Corrigendum – 3 Dated July 01, 2013 to Tender specification BHEL: PSSR: SCT 1532

Some of the bidders sought clarifications in the tender and the “clarifications issued” are furnished below for your information.

PROJECT: YERMARUS THERMAL POWER STATION
2X800MW

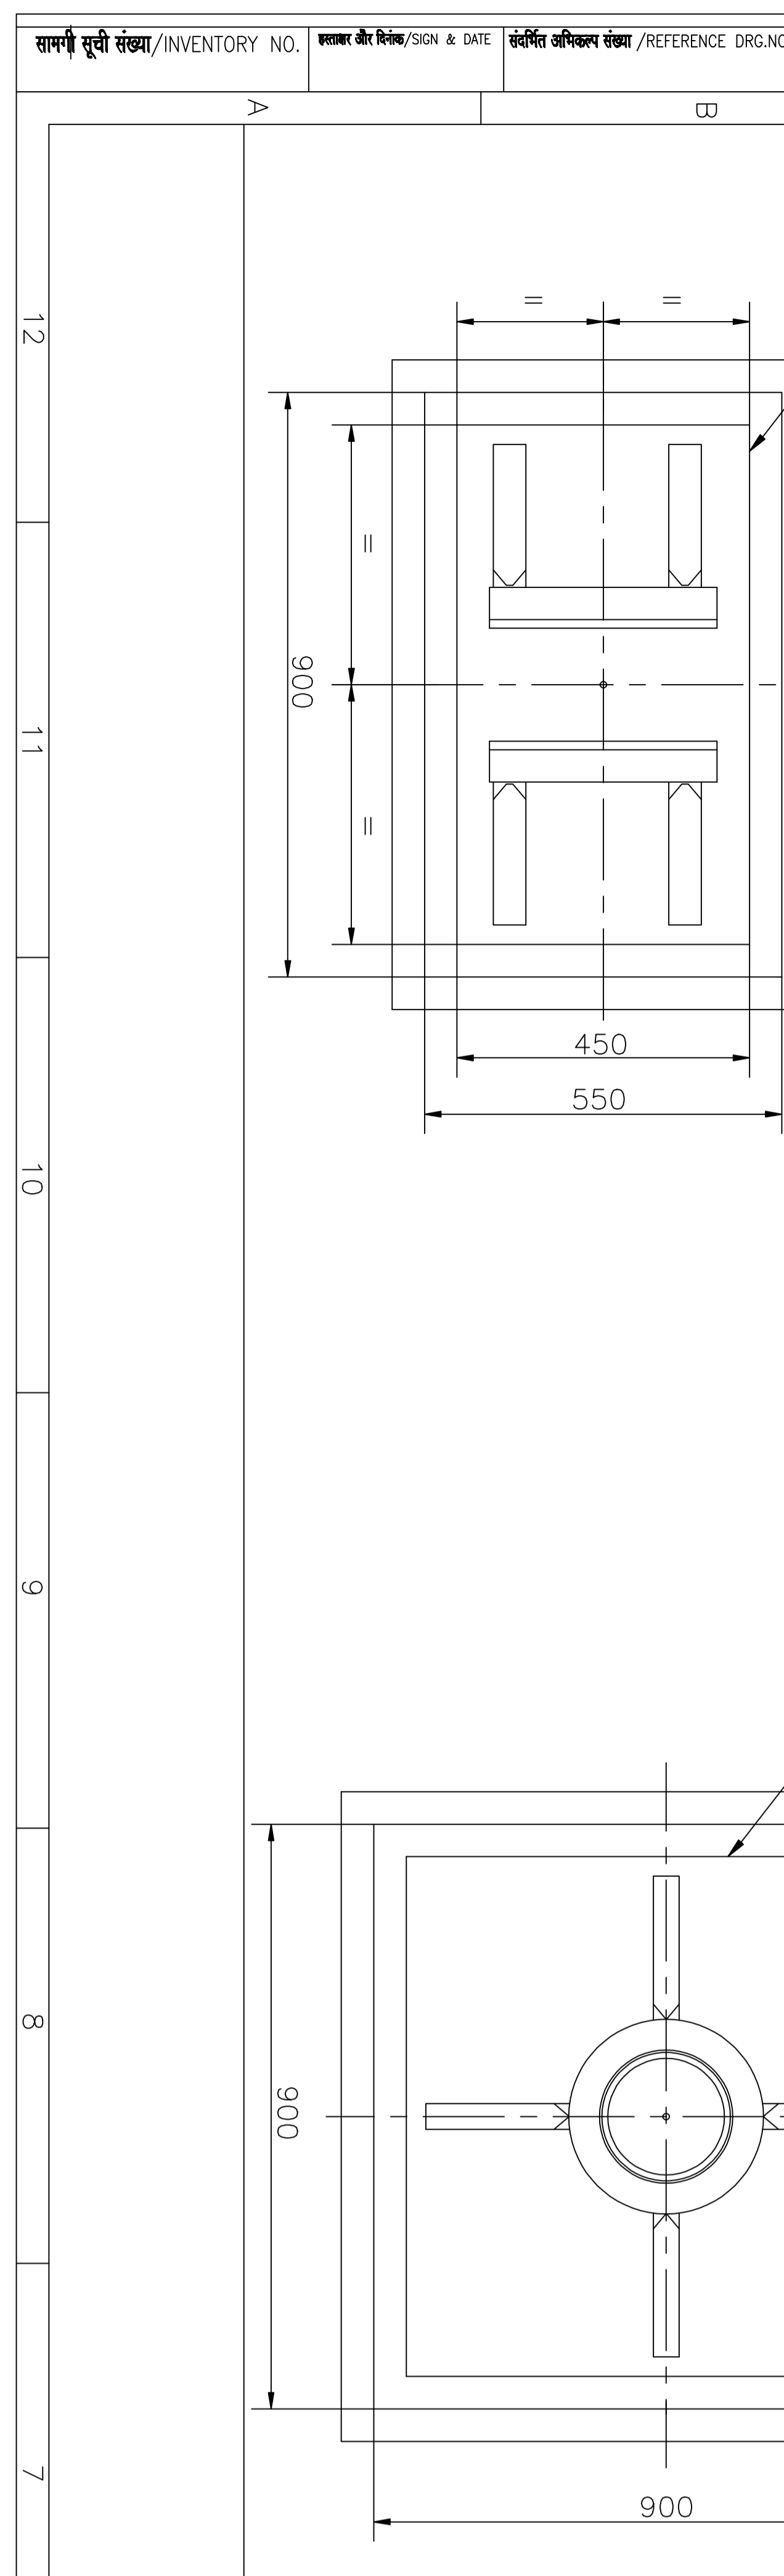
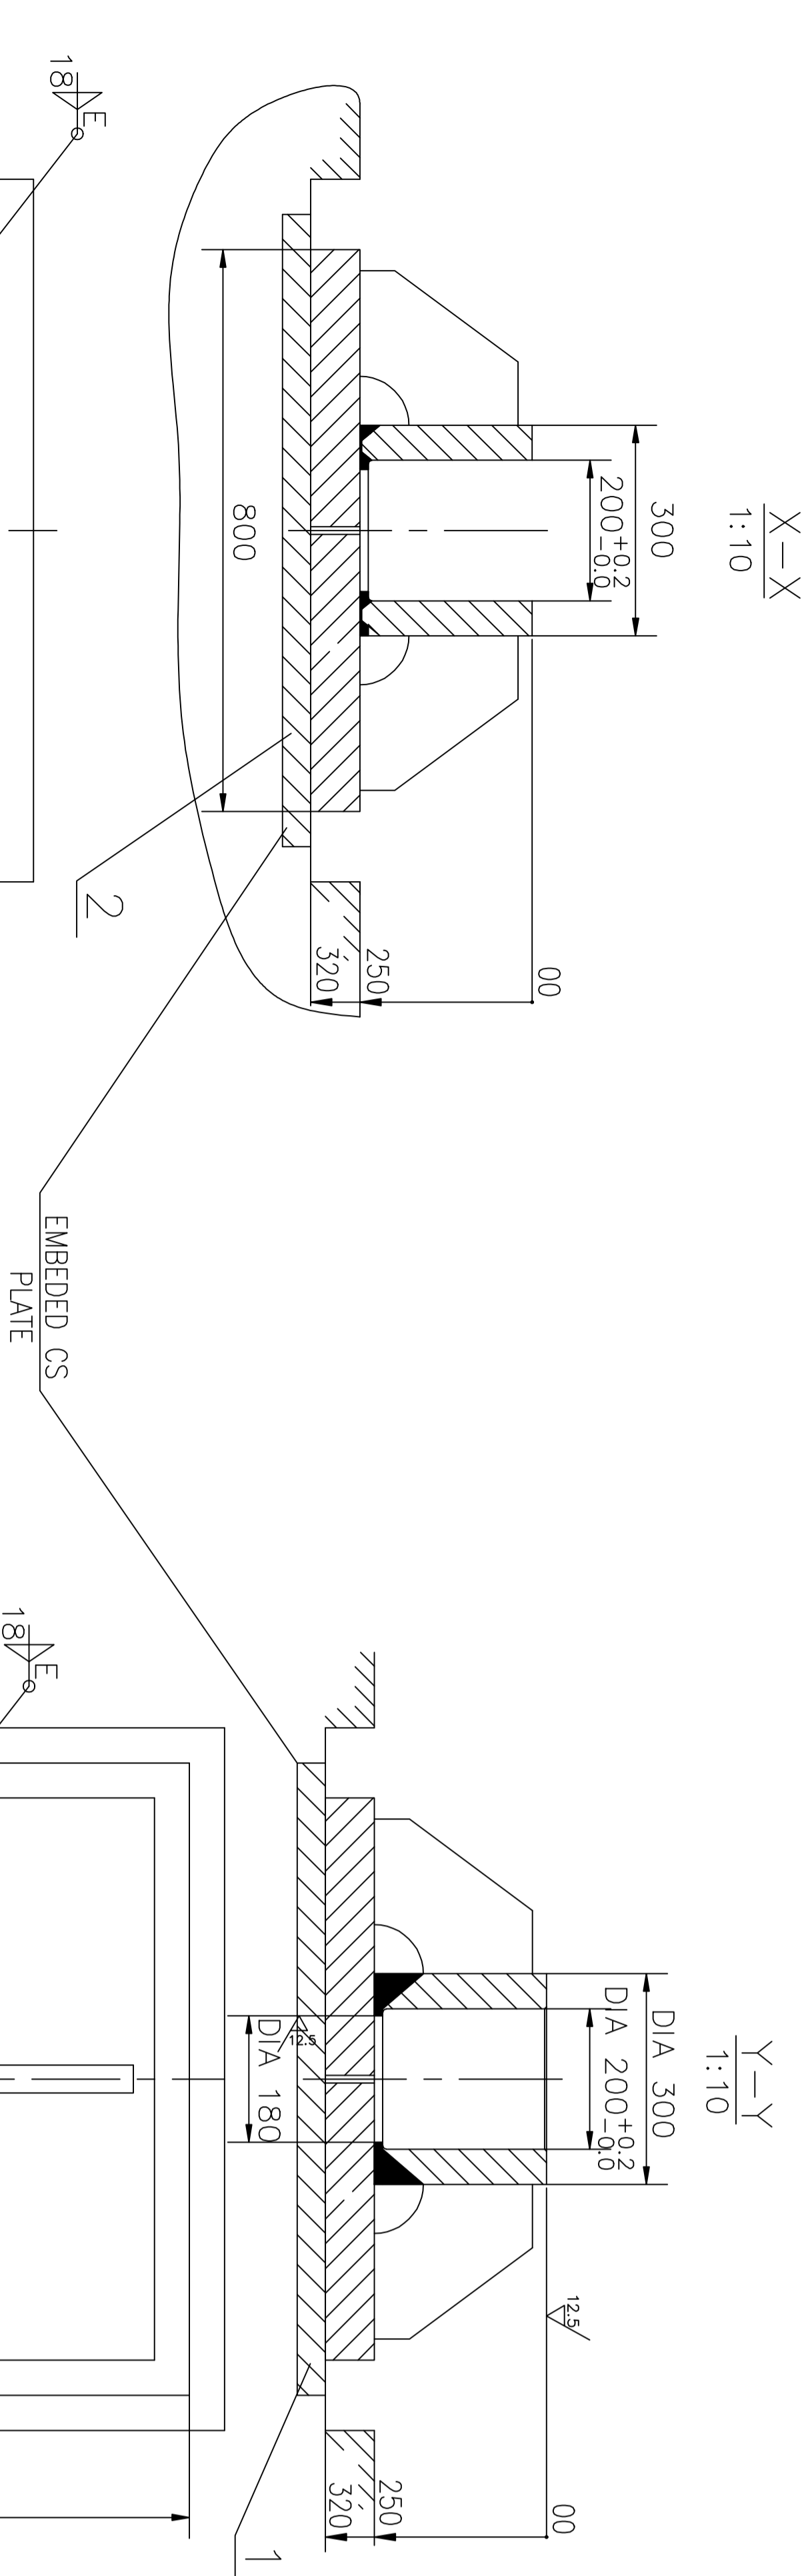
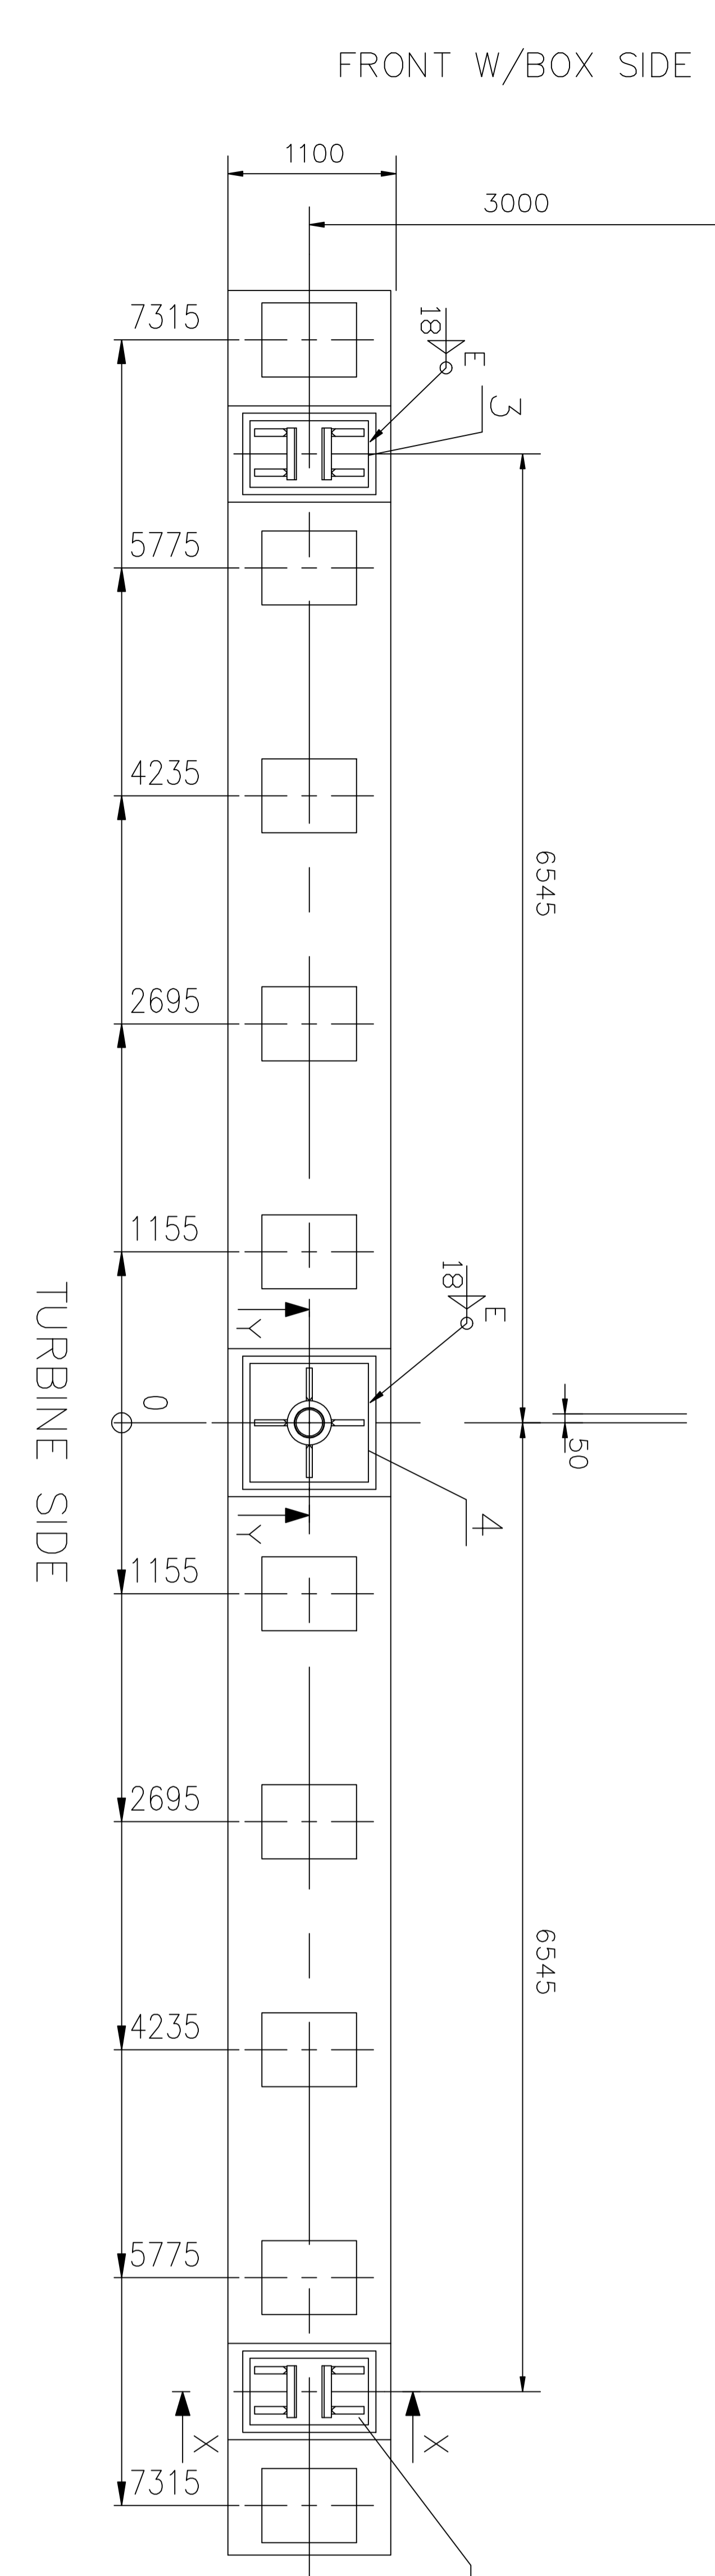
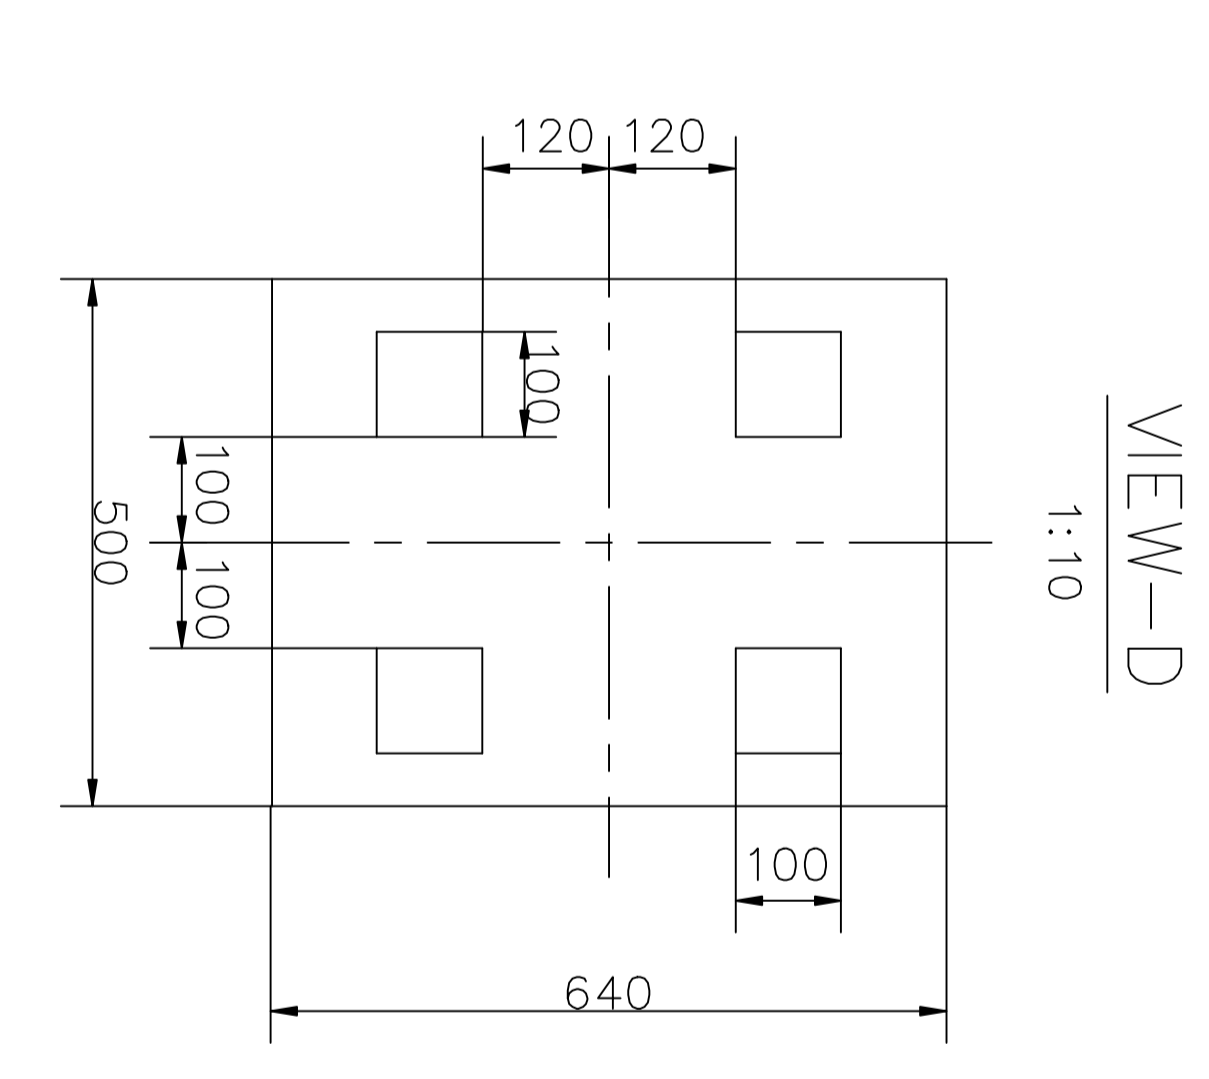
Sl. no	Published in	Existing clause	Bidder's queries	Clarifications issued by BHEL
26.	<p>Techno commercial bid Volume-I Book-I Volume-IA Part-I Chapter- XIII Clause no. 1.13.119.5</p>	<p>5. Bought out Items:</p> <ul style="list-style-type: none"> • Turbine Integral Piping Consists of Cross around piping • Condenser Tubes (welded Austenitic SS GR 316 L) • • • Multi ball bearing support for condenser 	<p>Please provide Condenser tube & BOI weight details.</p> <p>Confirm whether it is cross around piping or cross over piping</p>	<p>Condenser Tube details :</p> <p>a) Size: OD 28.575 mm X 0.7112 mm thick, length – 14730 mm.</p> <p>b) Material : welded Austenitic SS Tubes Gr 316 L</p> <p>c) Total no of tubes : (2 condensers / each unit: 44000 Nos (approximate)</p> <p>Cross around piping is to be corrected as Cross over piping.</p> <p>Drawing for Condenser support (Multi ball bearing arrangement) is enclosed.</p>
